Meeting: 3/16/2022
Applicant: Amber Culpepper Lafayette Investments LLC
Owner: Amber Culpepper Lafayette Investments LLC

Location: 3415 Gap Rd. **Parcel ID** 81 I T 011
Zoning: RN-2 (Single-Family Residential Neighborhood)
District: Lonsdale Infill Housing Overlay District

Level III New Primary Structure

Staff recommends approval of Certificate 3-H-22-IH, subject to the following conditions:

1 Site Setbacks & Layout
A100 1" = 20'-0"

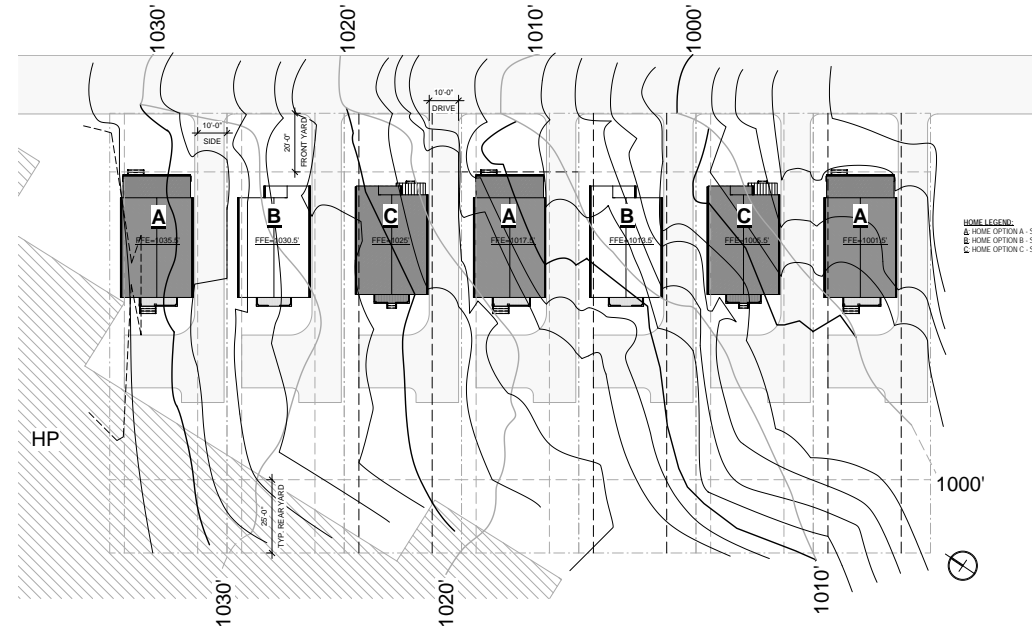
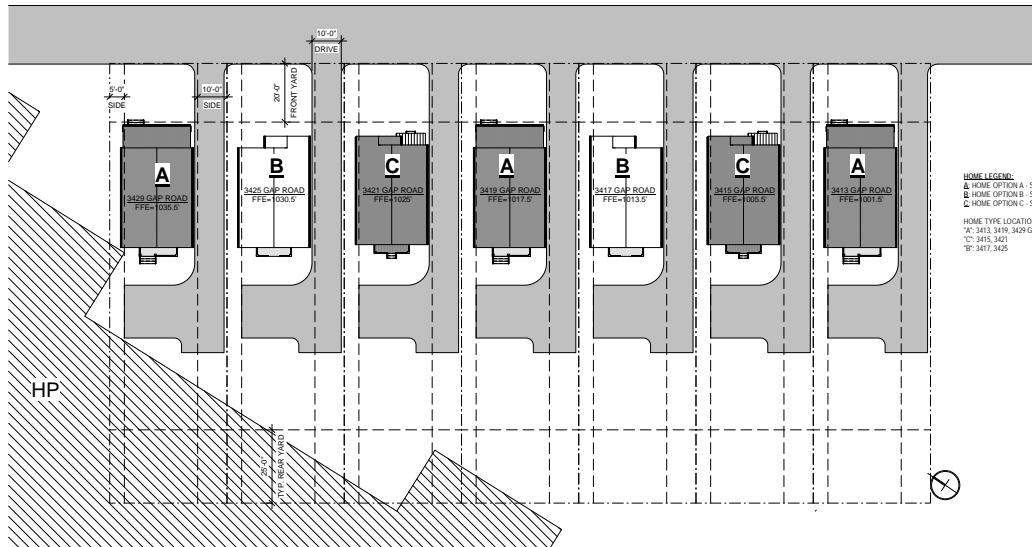
1. The proposed front setback is 24' from the front property line. There are only three other houses on the block. 3401 Gap Road is located 42' from the front property line, and the new construction houses at 3405 and 3409 Gap Road are also set 42' from the front property line. The subject property is one of seven new houses to be constructed on the block, so the front setbacks will effectively create a new street pattern. The submitted site plans do not specifically call out the front setback measurement. Overall, the proposed front setbacks should be confirmed to create consistent front yard spaces along the block.

The seven adjacent new houses will demonstrate consistent side yard setbacks while accommodating the necessary side driveways. The applicant should confirm the left side exterior walls of all 7 houses will stay within the 5' side setback required allow windows on side elevation walls.

3. There is no operable alley on the block. The proposed parking meets Infill Housing design guidelines by limiting access to one lane between the street and the façade, and the design benefits from the parking pads being placed behind the house. As proposed, the site plans meet City Engineering standards, but any modifications in permitting should meet Engineering standards and Infill Housing design guidelines.

- 1) Front setback should be confirmed to create consistent front yard space along the block, with approval of final site plans by staff;
- 2) Left side setback to be a minimum of 5', so the left side elevations can retain windows;
- 3) Final site plan to meet City Engineering standards and Infill Housing design guidelines;
- 4) Revise design of front porch to meet design guidelines, with approval by staff;
- 5) Add one bay of windows on the left side elevation, with approval by staff;
- 6) Final site plan to show one tree in front and one tree in rear yard.

Drawn: MSG
HOME OPTION C -
EXTERIOR
ELEVATIONS

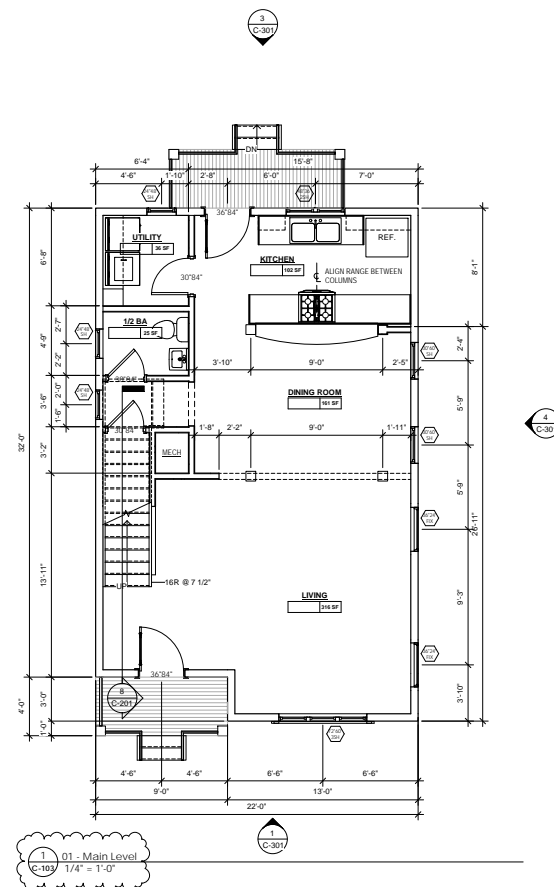
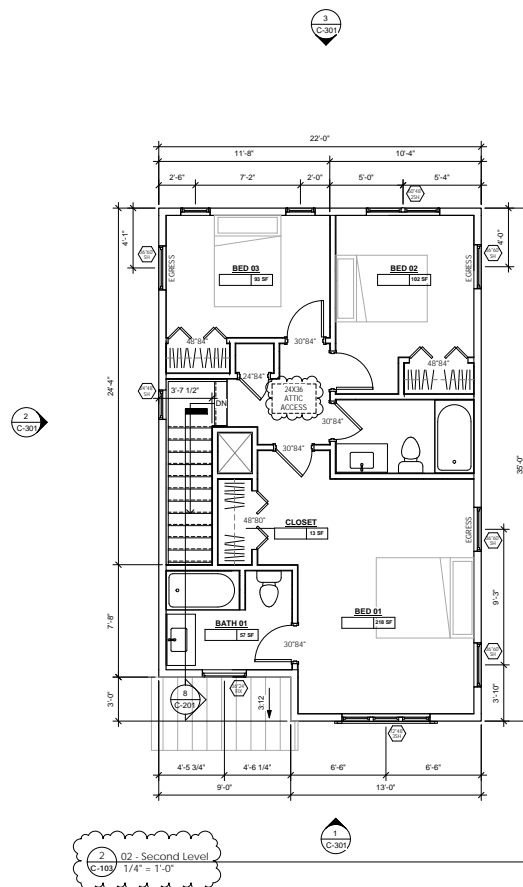
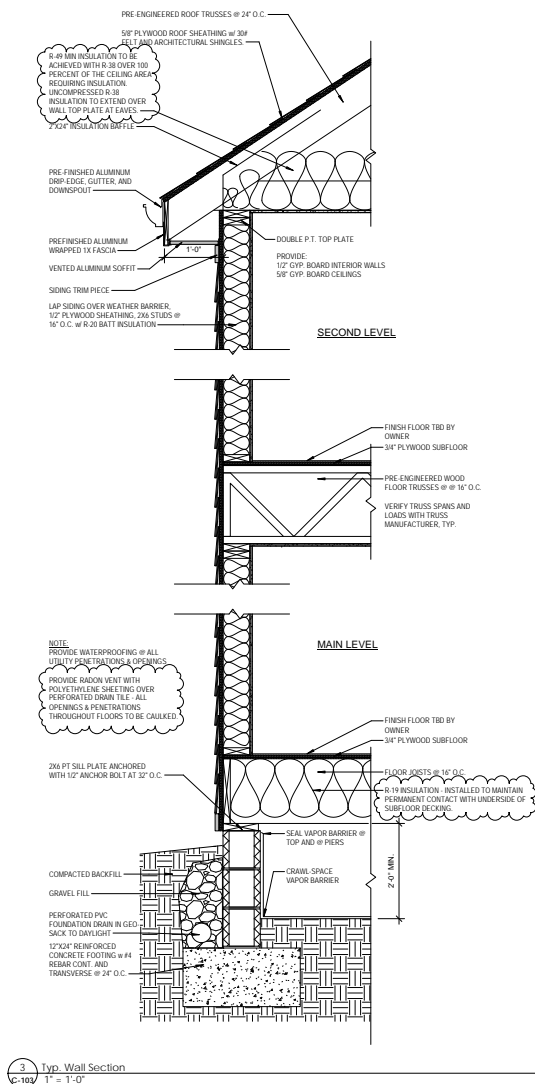
5. Design "C" proposes a 3' wide entry stoop instead of a porch. The new house should incorporate a porch to meet design guidelines, measuring 8' deep and with a roof proportionate to the overall design.

6. Guidelines note that "window and door styles should be similar to original or historic houses" in the surrounding context. 1/1 windows instead of the proposed 4/1 would be more appropriate for the surrounding context. The façade generally shows "similar proportion and position as original houses on the block," though the single fixed window is disproportionately small to the façade. The side elevations show multiple sizes of windows with somewhat irregular placement. The left side elevation would benefit from an additional bay of windows closer to the façade, as the large swath of wall with no transparency will be significantly visible from the street.

7. At 6/12, the roof has a similar pitch to original houses in the neighborhood. The 3/12 pitch, shed roof will be somewhat shallow in proportion to the rest of the house.

8. The proposed materials meet the design guidelines. While vertical siding is often discouraged as a primary siding material for new houses, it will add detail between the first and second stories.
